Proposed Corriegarth 2 Wind Farm: Response to SEPA Objection Letter

I am writing with regards to the objection that the Scottish Environment Protection Agency ('SEPA') submitted (via Email) to the Scottish Government's Energy Consents Unit ('ECU') on 12 August 2021, in relation to the proposed Corriegarth 2 Wind Farm ('the Development').

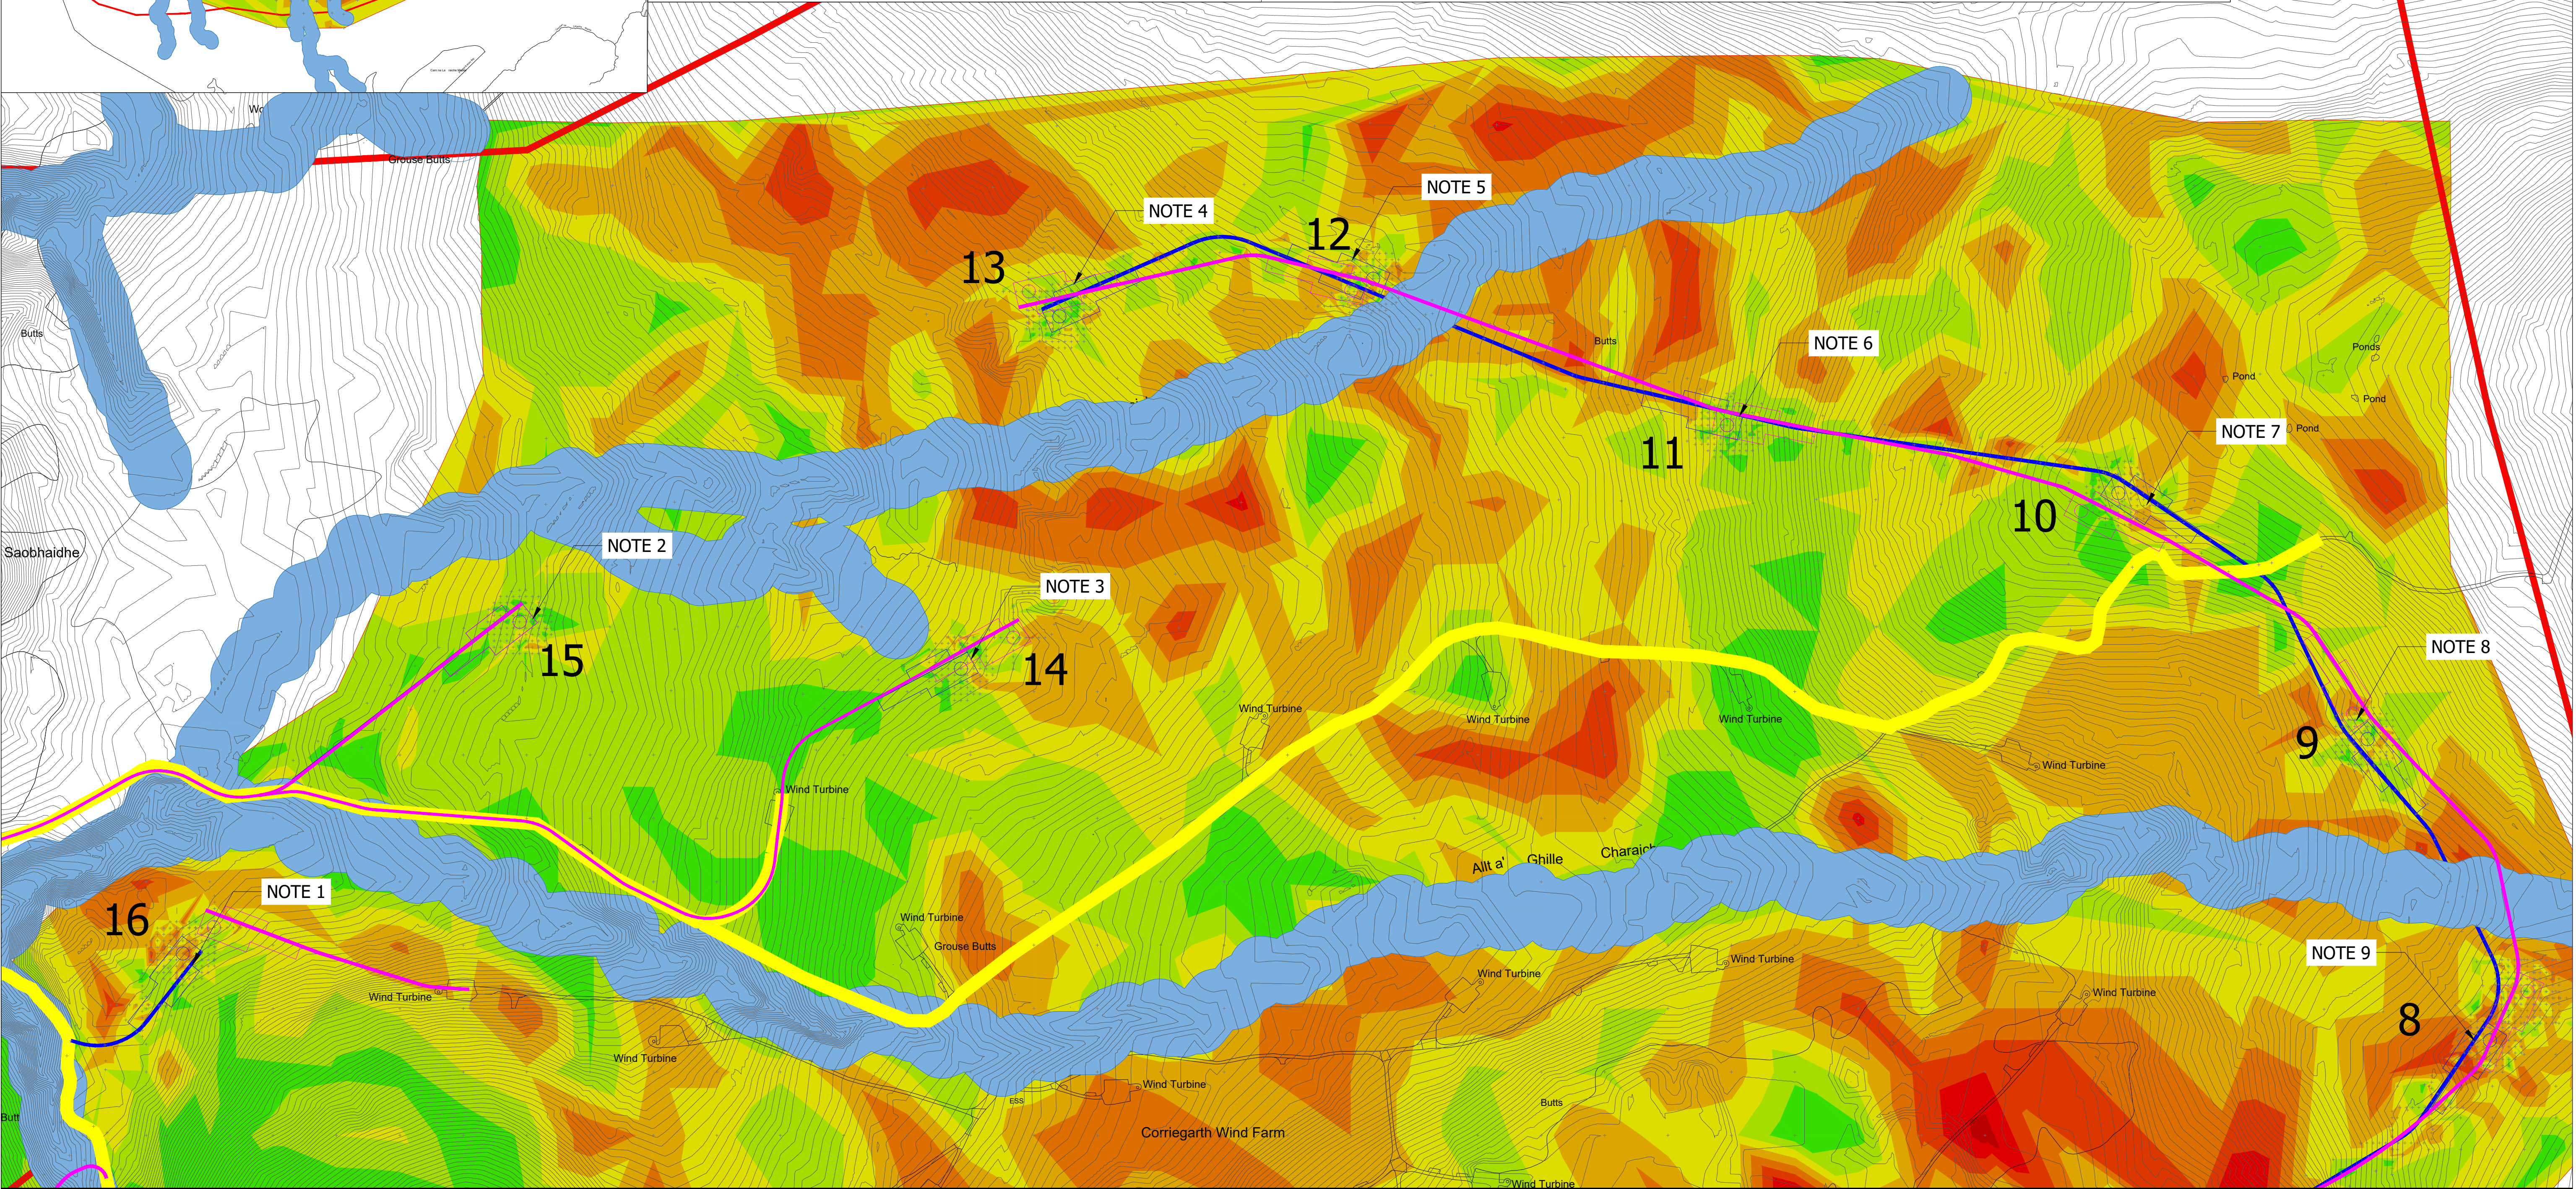
1. The overall track length should be shortened by losing some of the links between turbines, this could also reduce the number of watercourse crossings and further reduce peat disturbance.

2. The section of track between T11 and T12 appears to have been moved northwards onto deeper peat. The track should be re-routed south onto shallower peat.

3. It should be considered whether the track layout to T8 can be refined, or possibly if T8 should be removed from layout due to environmental constraints. The current layout links T8 to both T7 and T9 which results in excessive track length, development on deep peat and the need for a watercourse crossing.

If T8 is to remain as part of the layout, the following options should be explored, (1) Remove the section of track from T8 to T9 thereby reducing overall track length and removing the need for a watercourse crossing; or (2) Re-route the section of track to directly link T7 to T8 thereby avoiding the area of deep peat the track crosses in the current layout design.

4. With regards to the revised turbine and infrastructure locations, it looks like there could be some further opportunities to minimise the environmental impacts by making some slight modifications. Move T1 slightly to the NW to remove it from the watercourse buffer.

5. Align infrastructure at T4 from NW to SE along the shallower peat.

6. Move T5 slightly east onto shallower peat.

7. Flip T6, T9 and T12 onto the opposite side of the track where the peat appears to be shallower.

8. Maintain original positioning for T14 as the modifications result in a longer track and more peat disturbance.

During the design process a track layout based on "spokes" or spurs from Corriegarth 1 (rather than a continuous link between the Corriegarth 2 turbines) was considered however this approach was rejected as it would have resulted in: limited reduction in water course crossings; and required crossings to be located in a less favourable positions and increased earth works.

In particular the location of the link between the southern turbines (T1 – T7) and the existing site was selected following due consideration of peat depths and topography, the maintenance of the 50 m watercourse buffer, and limiting the crossing of the River E. Although the number of watercourses could be reduced by branching off existing wind farm tracks and crossing the River E tributary it was considered that such a track design would have a greater impact as the crossings locations would be over a more substantial watercourse compared to crossing closer to the head of the minor tributaries. The impact would be further increased due to the orientation of the shorter tracks, traversing against the topography, which would require significantly increased earthworks to deliver the required track gradient (to comply with turbine manufacturers delivery specifications).

The refined track alignment was aligned and orientated to benefit and minimise the peat disturbance at the turbine foundation locations (T11 and T12). Use of a shorter section of floating track in this location is deemed a better technical and environmental solution than routing the track around the area of slightly deeper peat.

The section of track between turbines T7, T8 and T9 is key to optimising the access which follows on to T10 – T13. Where required 'floating tracks' will be used to minimise impacts on peat.

The re-routing of the track to be directly between T7 and T8 would result in that section of track lying perpendicular to the direction of the contours which would create a steep section of track requiring significant earthworks and, based on our experience of construction on similar sites, a 'floating track' solution as proposed is more appropriate in this location.

Moving T1 NW would result in increased landscape and visual effects. In its current location it is only the crane hardstanding which overlaps the watercourse buffer; this is an area which requires to be clear of any obstructions for lifting, and therefore will not be subject to any ground breaking during construction.

In order to maintain the 50 m watercourse buffer, and based on our site knowledge and technical opinion, T4 is in the best location to minimise impacts on deep peat. Likewise the current track arrangement, is also aligned with, and dictated by, the topography in order to reduce earthworks required.

A move east would impact a small pocket of deeper peat which up until now has been avoided. T5 crane hardstand has been orientated to accommodate the track orientation designed to minimise the impact on peat.

The changes proposed here could be captured through micro-siting, as there are marginal refinements that could improve the impact on peat. Any such micro-siting would take into account topography and the detailed site investigation results.

Minor movement of T14 was required to reduce the visual horizontal extent of the turbine layout whilst maintaining a balanced visual composition from key landscape receptors. A micro-siting move of up to 50 m is possible between the two turbines and crane hardstand arrangements presented on Figure 3369-DR-P0001A, which would reduce the impact on peat. Any such movements would be informed by the detailed site investigations.
